Access Compliance Report

Public Rights-of-Way

Intersection ID: N/A	Main Street: BLAKENEY PROFESSIONAL_W	Cross Street: N/A	Location: E
ADA ID: CCD1267997EB	Ramp Type: PerpDiag	Initial Pass/Fail: Fail	Overall Compliance: No
Severity Score: 21.25			
Codes/Mitigation Info/Possible Solution		Field Measurements/Component Compliance

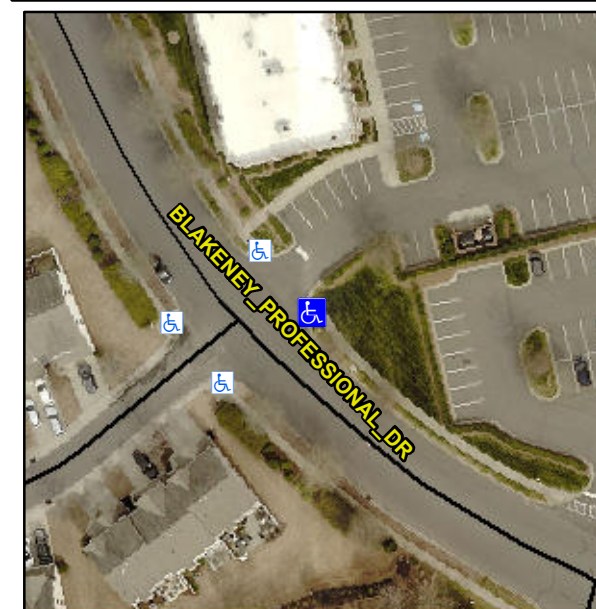
R304.5.1, R304.2.2

Compliance	Description	Data	Compliance	Description	Data
N/A	Ramp Length (in)	81.0	No	Ramp Slope (%)	8.6
No	Ramp Width (in)	44.0	Yes	Ramp XSlope (%)	2.0
N/A	Flare Type LT	N/A	N/A	Flare Type RT	N/A
N/A	Flare Slope LT (%)	N/A	N/A	Flare Slope RT (%)	N/A
N/A	Flare Traversable LT?	N/A	N/A	Flare Traversable RT?	N/A
N/A	Landing Length (in)	N/A	N/A	DWS Provided?	N/A
N/A	Landing Width (in)	N/A	N/A	DWS Contrast?	N/A
N/A	Landing Slope (%)	N/A	N/A	DWS Length (in)	N/A
N/A	Landing X Slope (%)	N/A	N/A	DWS Full Width?	N/A
N/A	Landing Curb? (Y/N)	N/A	N/A	DWS Offset (in)	N/A
N/A	Shared Landing?	N/A			
N/A	Gutter Ponding?	N/A	N/A	Gutter Slope (%)	N/A
N/A	Gutter Lip Ht (in)	N/A	N/A	Gutter X Slope (%)	N/A
N/A	Painted X Walk1?	No	N/A	Painted X Walk2?	No
	X Walk 1 Direction	To NW		X Walk 2 Direction	To SW
N/A	X Walk 1 Width (in)	N/A	N/A	X Walk 2 Width (in)	N/A
	X Walk 1 Slope (%)	2.6		X Walk 2 Slope (%)	5.2
	X Walk 1 X Slope (%)	1.7		X Walk 2 X Slope (%)	2.7

Remove & Replace Curb Ramp With Two New Directional Ramps or Equivalent.
